SAFETY DIRECTIVE

Check of throttle control guides Model G-3/600

Issue number: SD G3-1-2005

Figure 1-1

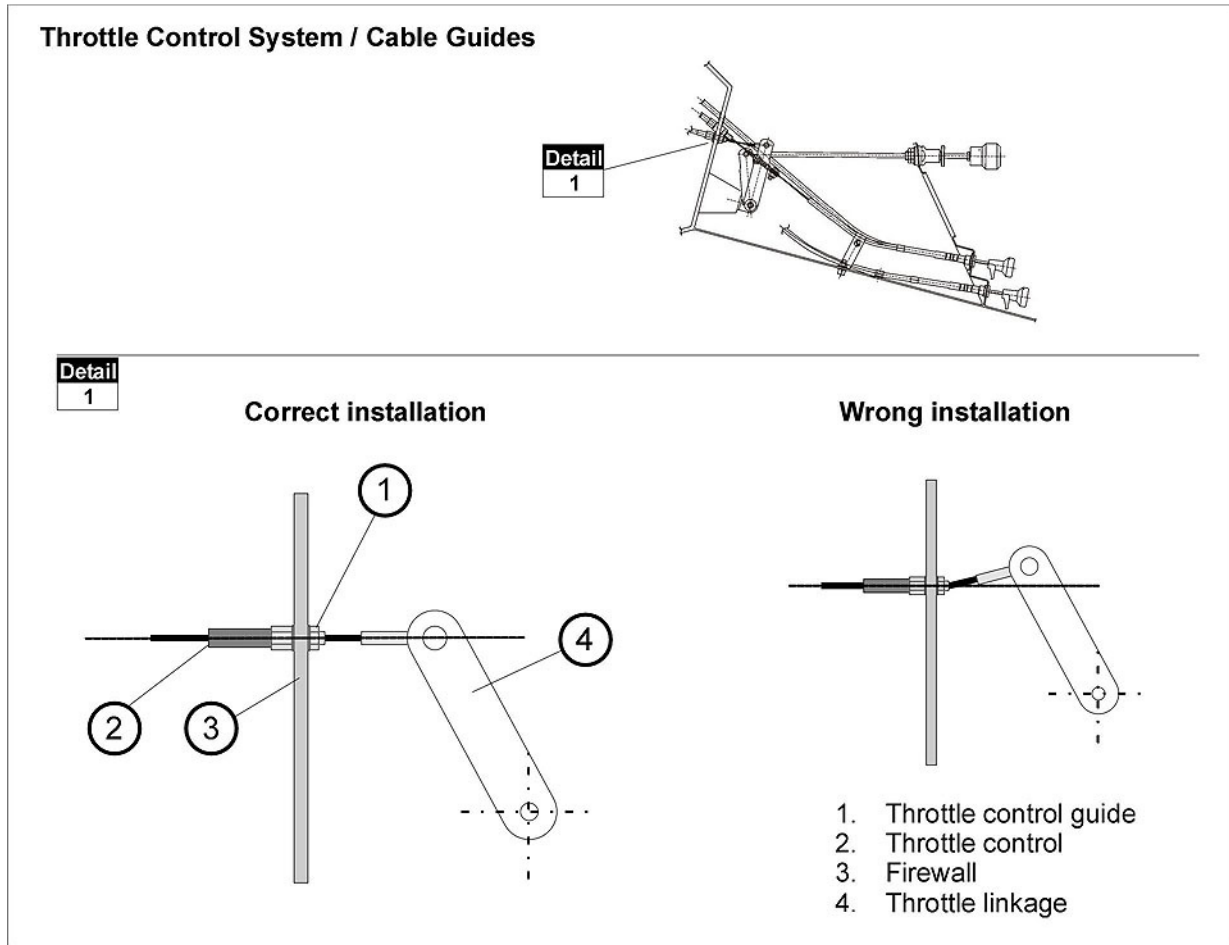
Reason: Uncorrect fitment of throttle control cable guides

Instructions: Check location of throttle control guide as illustrated in figure 1-1 and restore to original operating configuration.

Test / Inspect: Conduct test run and rigging of throttle controls in accordance with current Maintenance Manual of the G-3/600.
